Design Review Board Study Session

SUBJECT: DR14-33, PADS B AND D AT AZ AVE WINCO

DR14-33, Pads B and D at AZ Ave Winco: site plan, landscape plan, grading and drainage, elevations, floor plans, lighting, colors and materials for approximately 2.0 acres located at the northeast corner of Arizona Avenue and Desert Lane zoned General Commercial (GC) with a Planned Area Development (PAD) overlay.

PAD B SITE PLAN
SCALE: 1" = 15'-0"

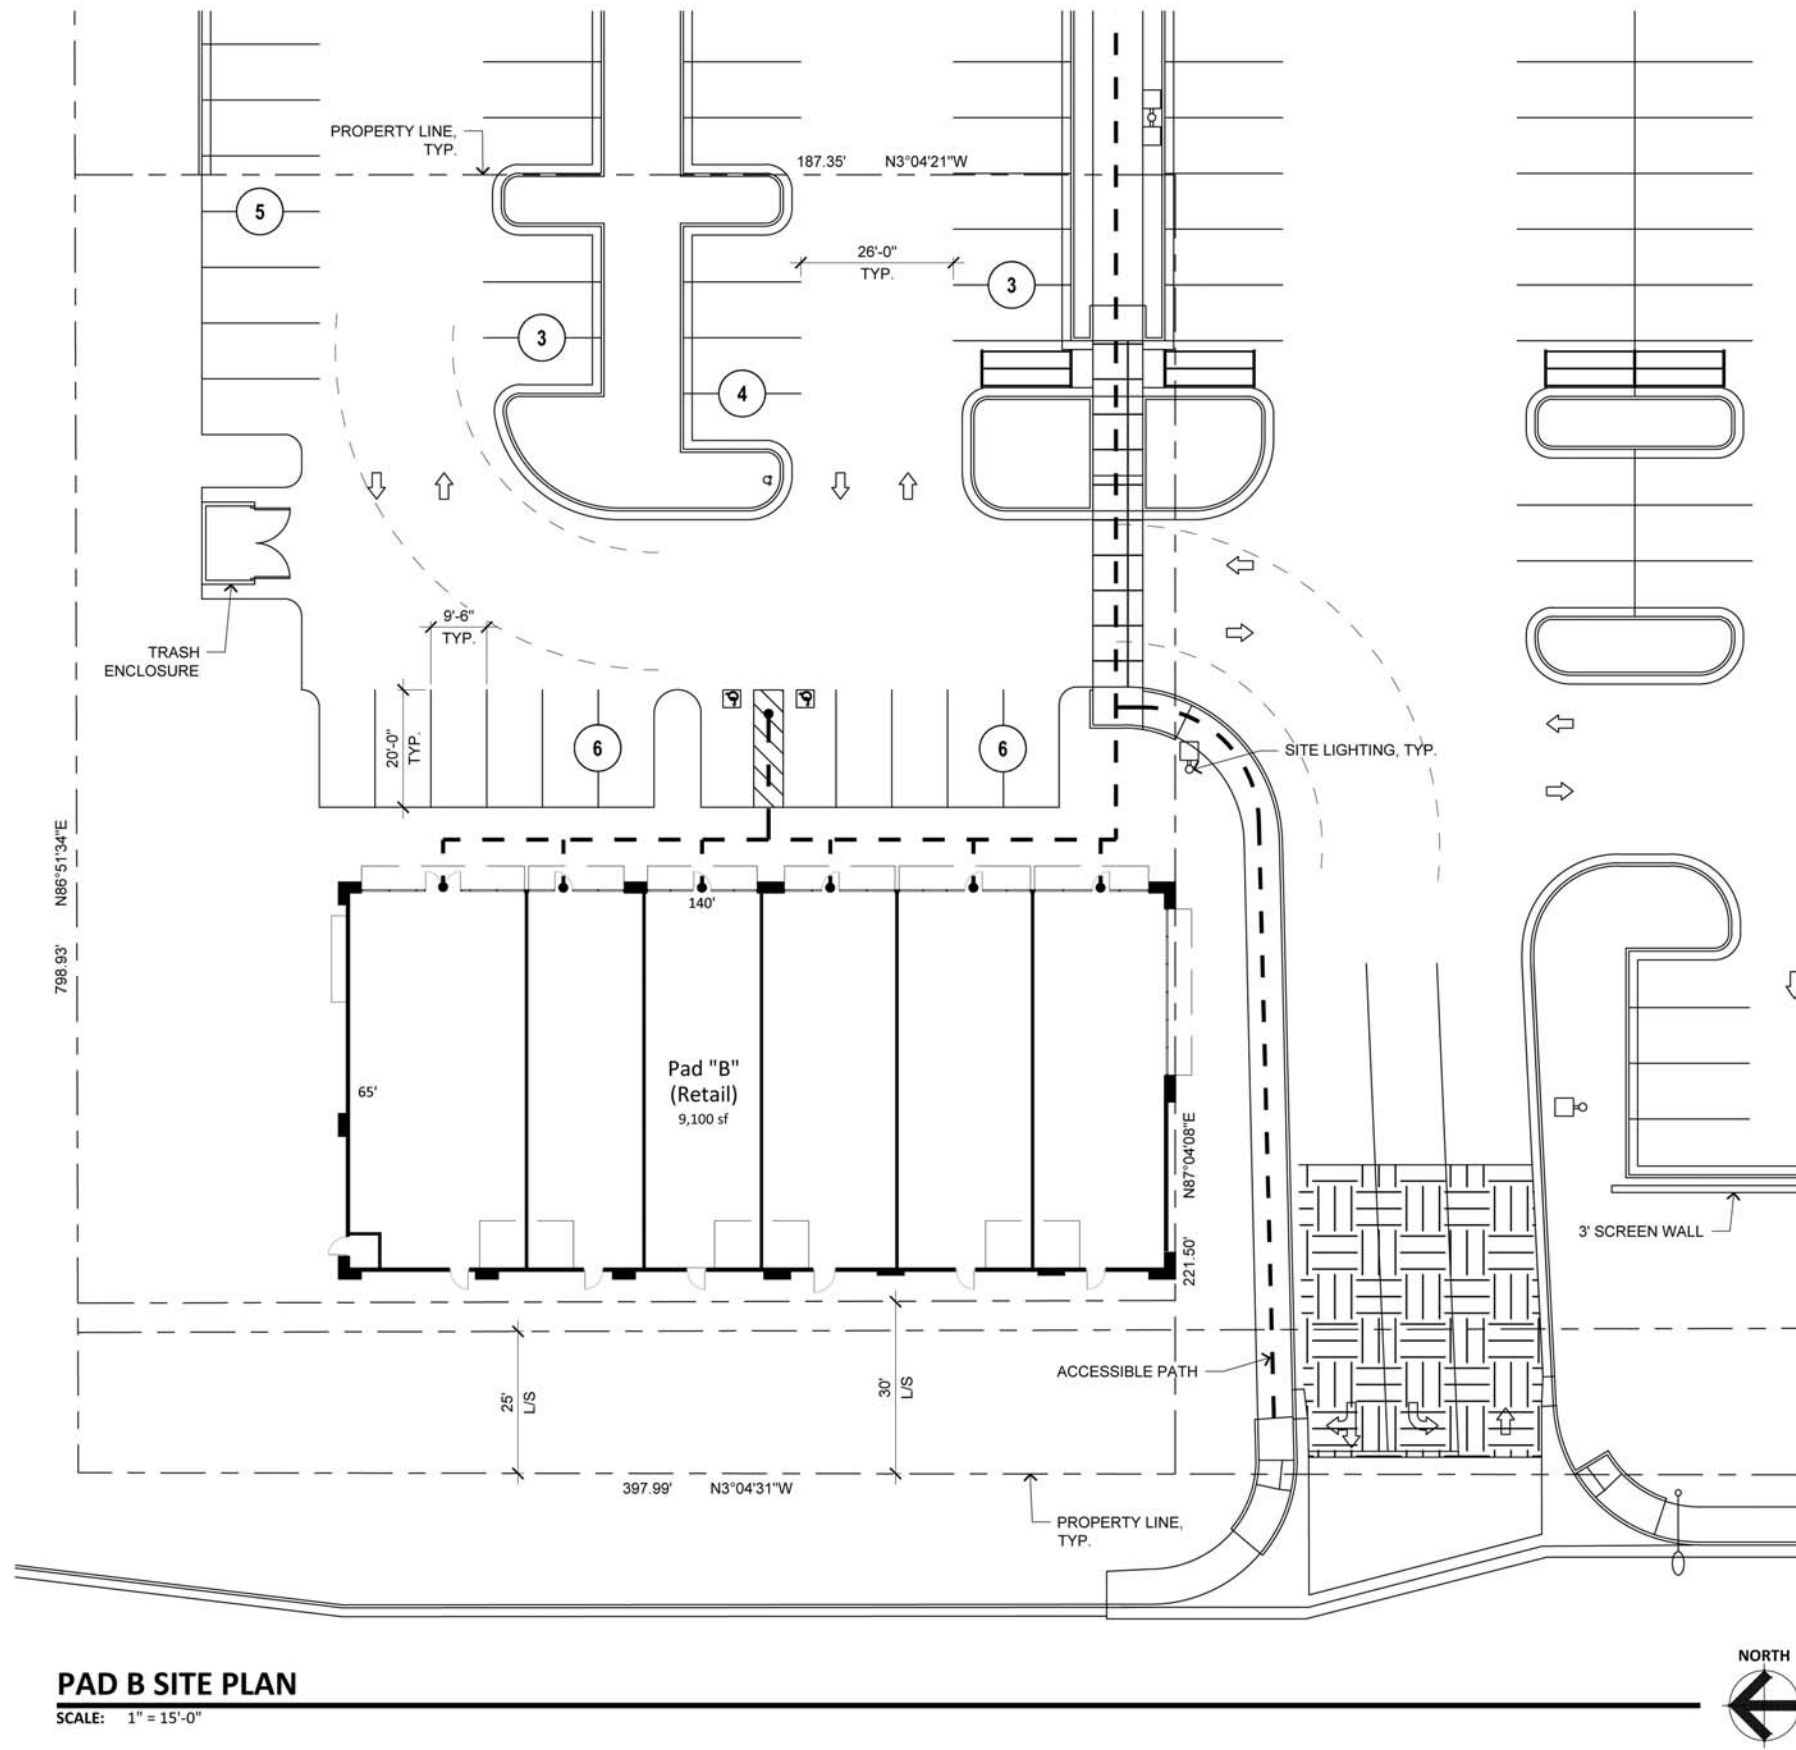
The Master Site Plan was approved in DR12-24. The proposed development for Pads B and D is in keeping with the approval. Staff has commented about Pad B concerning access to the rear

store access. There is no direct access from a parking lot to the rear service doors. It appears that the sidewalk access to these doors comes from the main entry sidewalk along the main drive aisle. Staff would prefer that an additional sidewalk be designed that connects the parking lot on the east side to the service door access on the west side of the shops. The sidewalk would be located along the north elevations and be a minimum of 3' from the building to allow for foundation landscape. The north side, adjacent to the sidewalk would also be a good location for an employee amenity area with shade and a bench/table. Another option would be to split the building and provide a center shaded plaza for outdoor dining and access to the rear. This would also help break up the west elevation.

SHEET TITLE: GRADING AND DRAINAGE PLAN

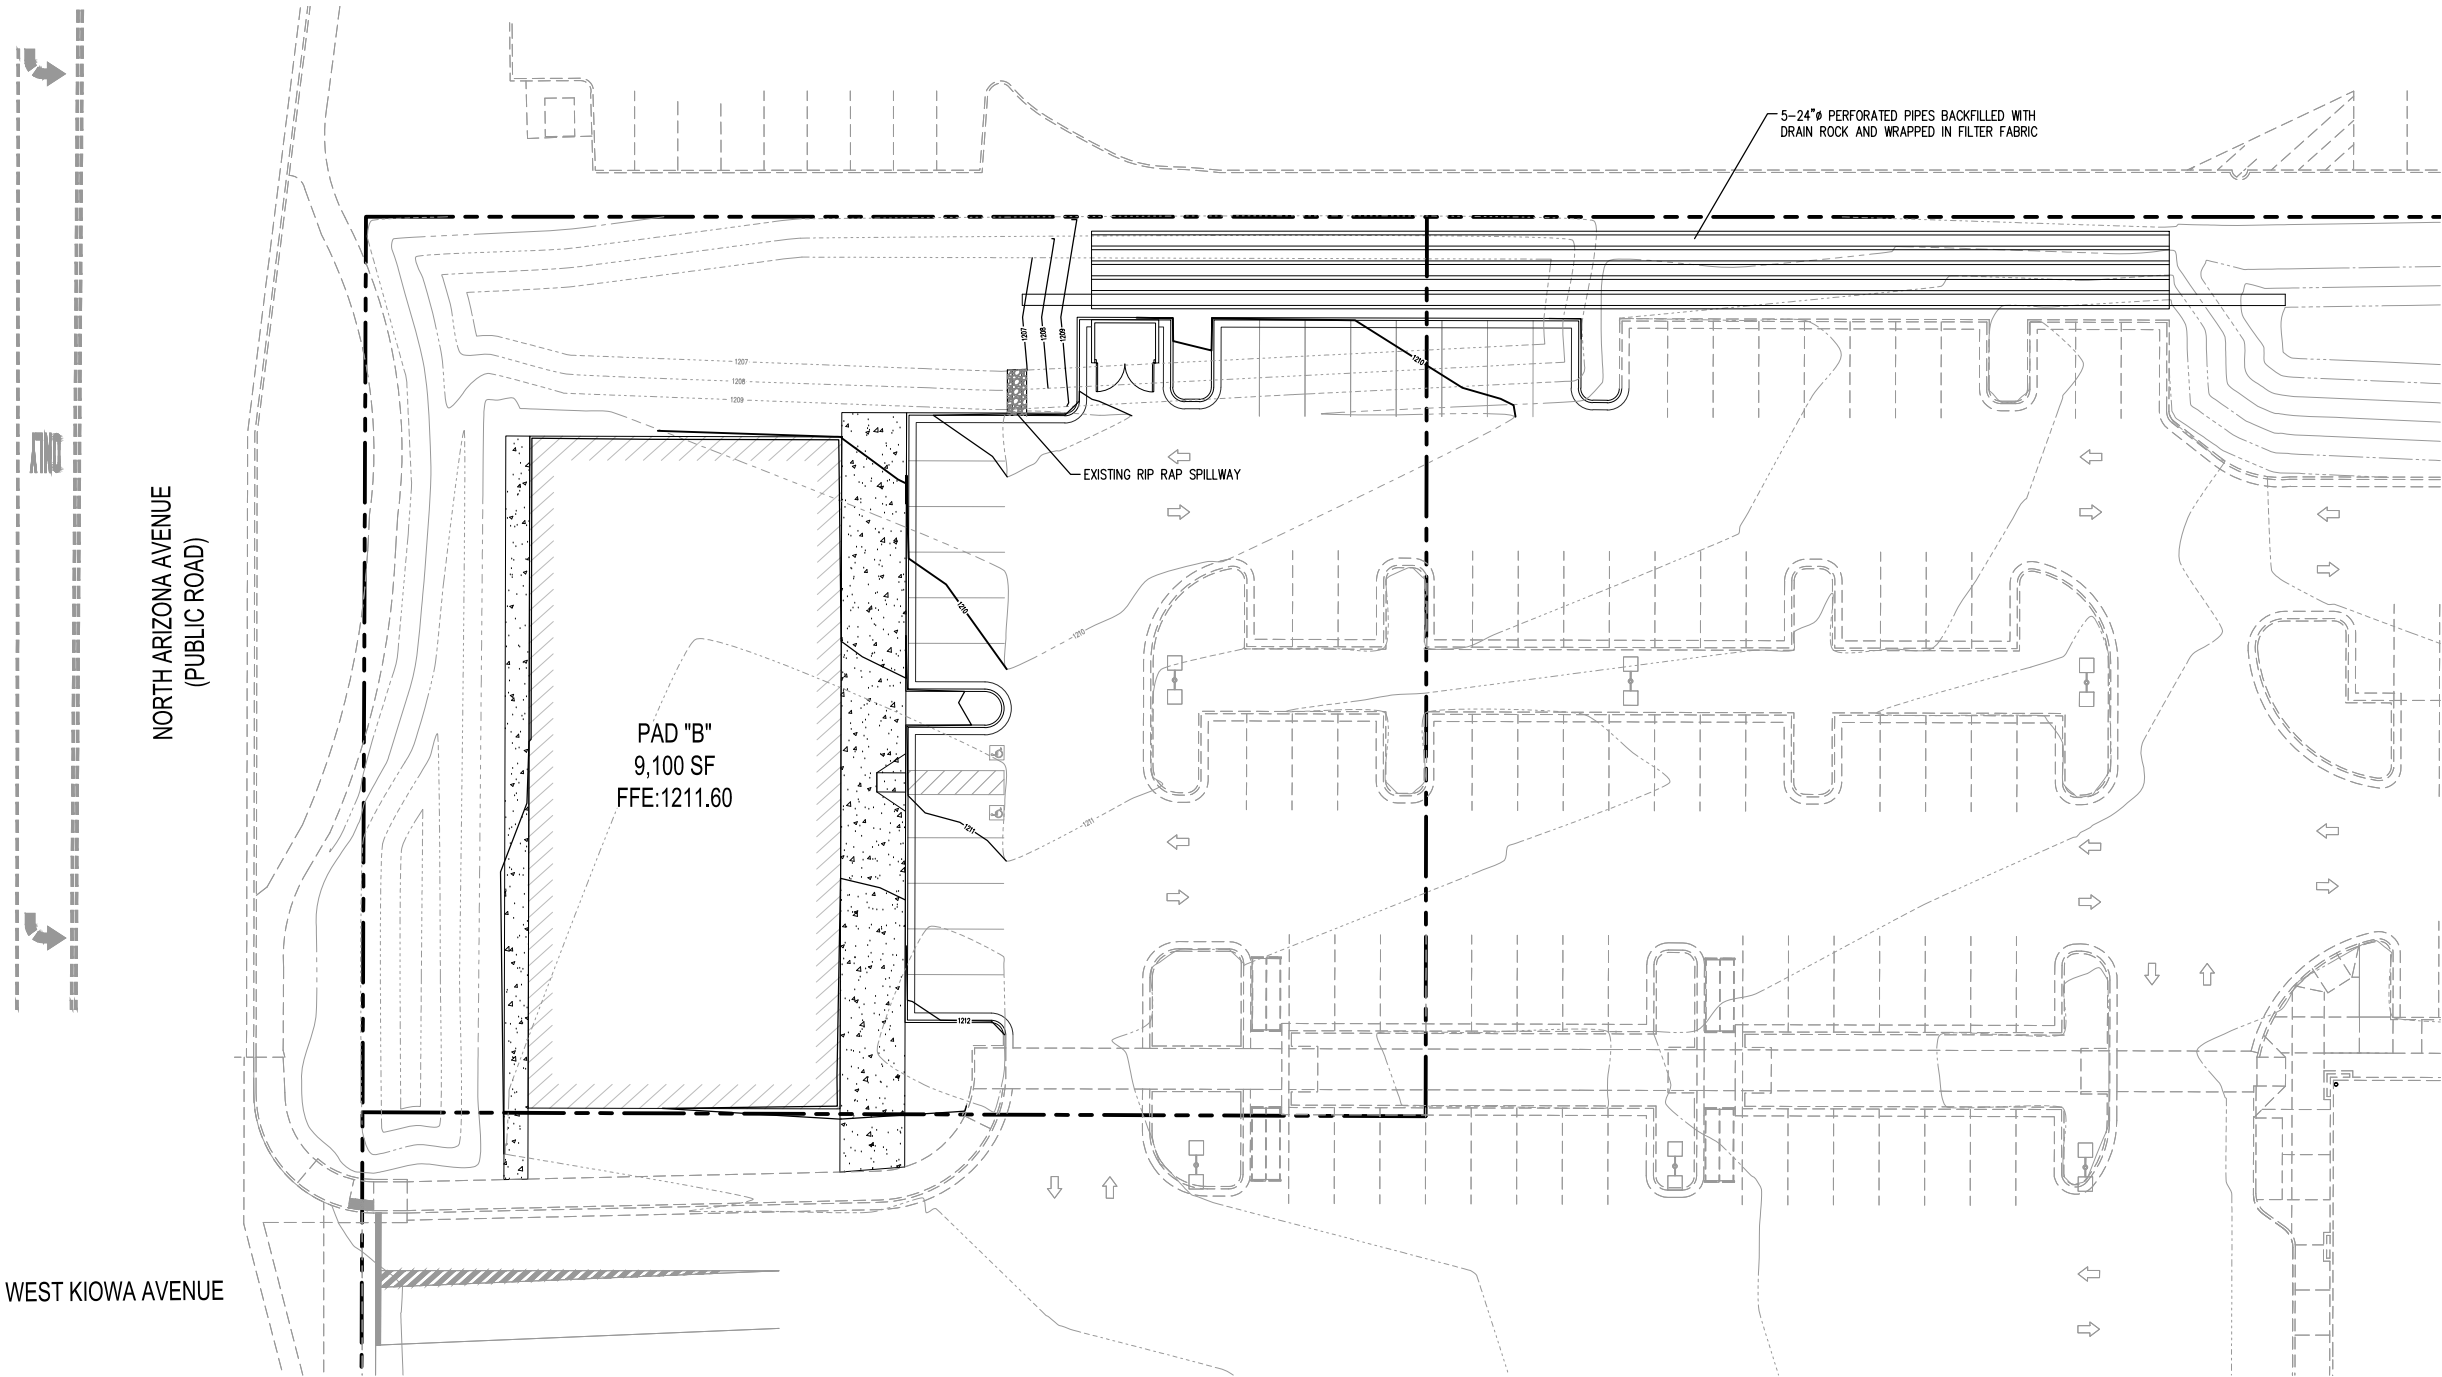
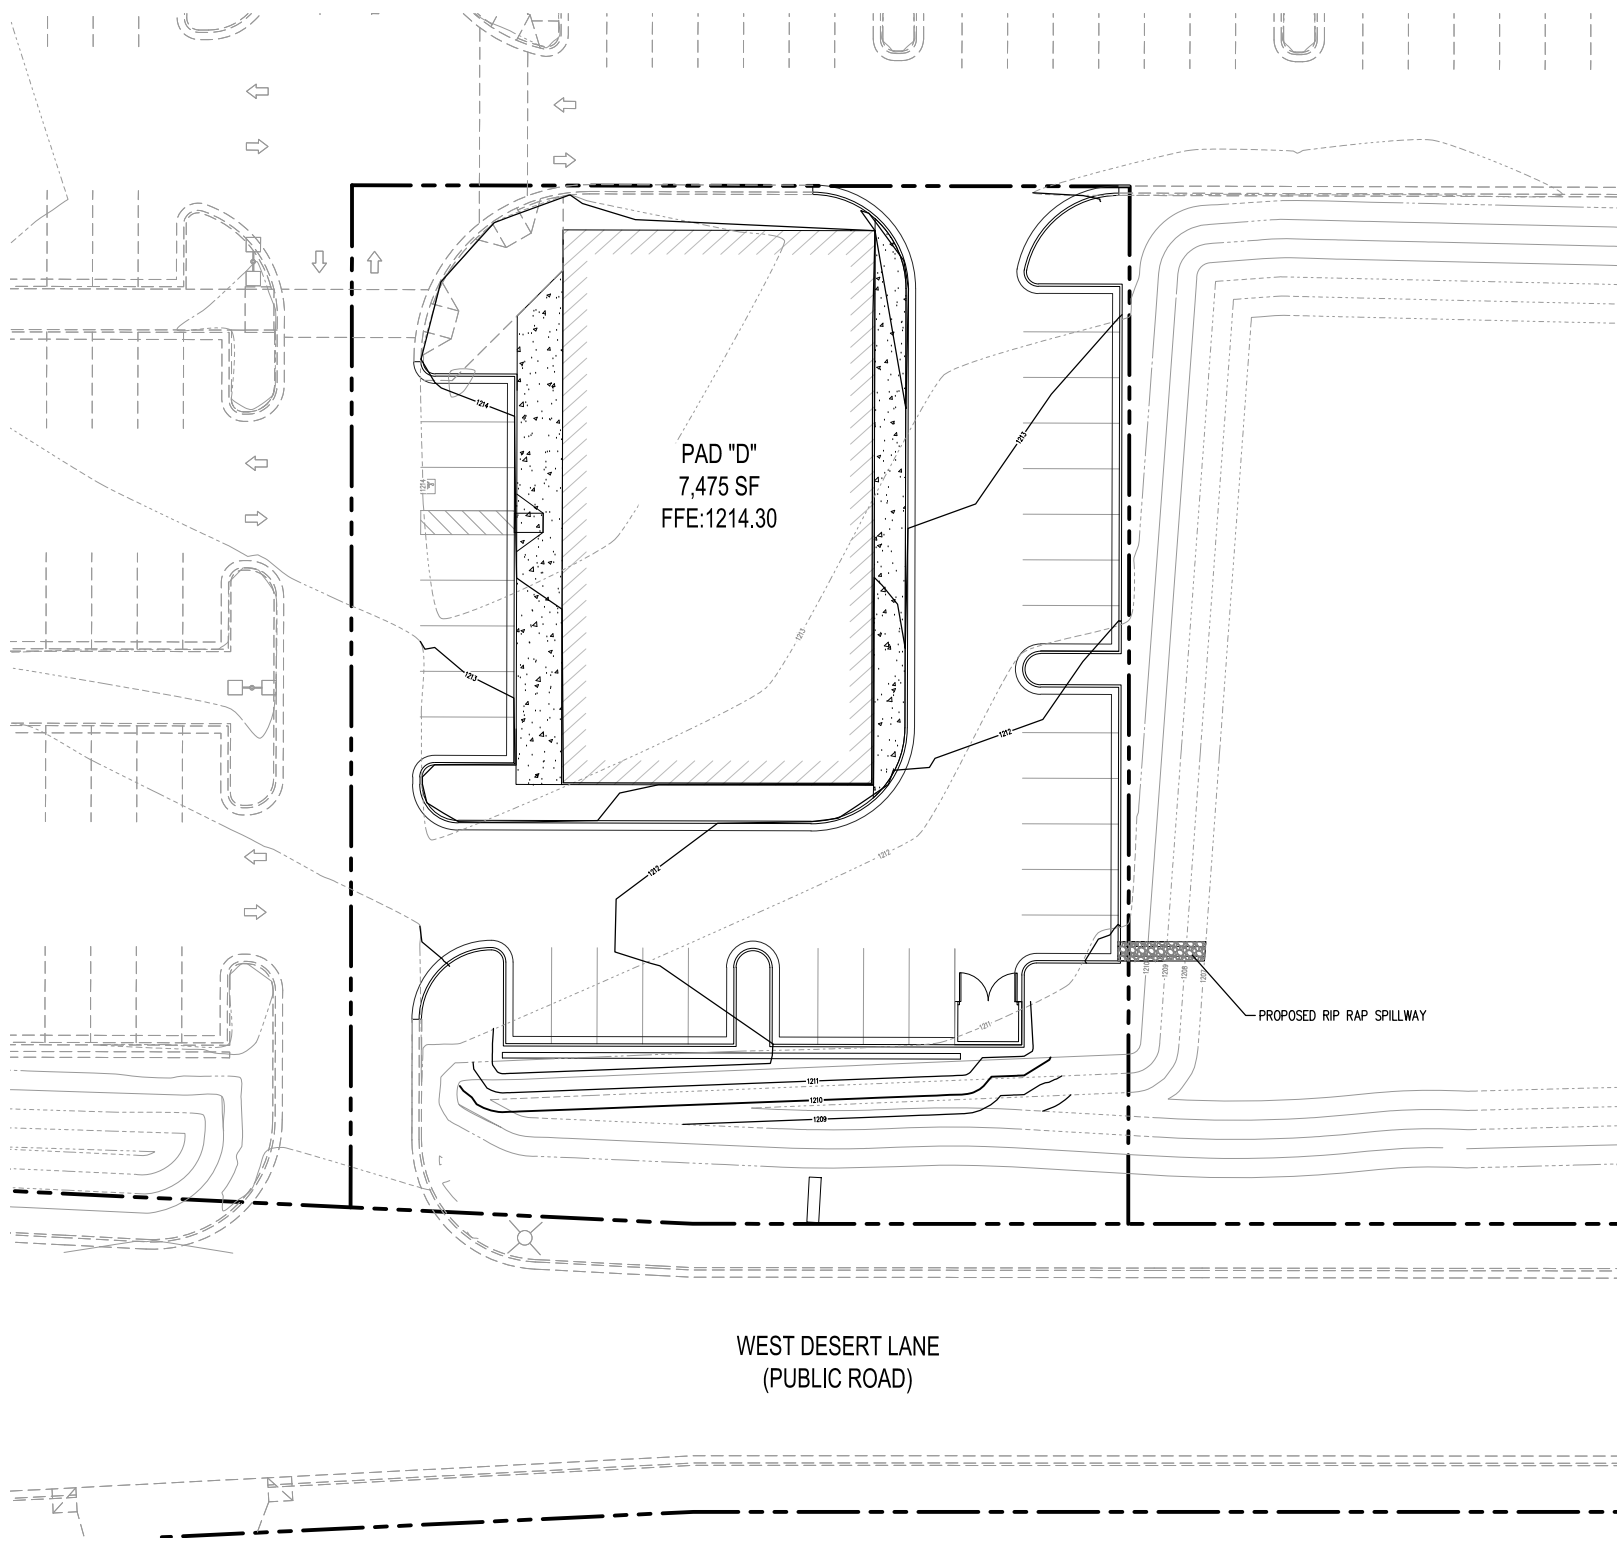
Pad B is proposing the addition of five 24" perforated pipes, backfilled with drain rock and wrapped in filter fabric along the north property line beneath landscape that is being installed with Pad A. There are existing trees along the north property line. Trees are required along the north property line at a minimum of 24" box trees every 3/1000 sq. ft. If the existing landscape is removed, the new landscape would have to meet this requirement even if it is in excess of what exists today. If the underground retention would prohibit the trees from this location, another drainage alternative would have to be found. Staff does not encourage the removal of mature landscape.
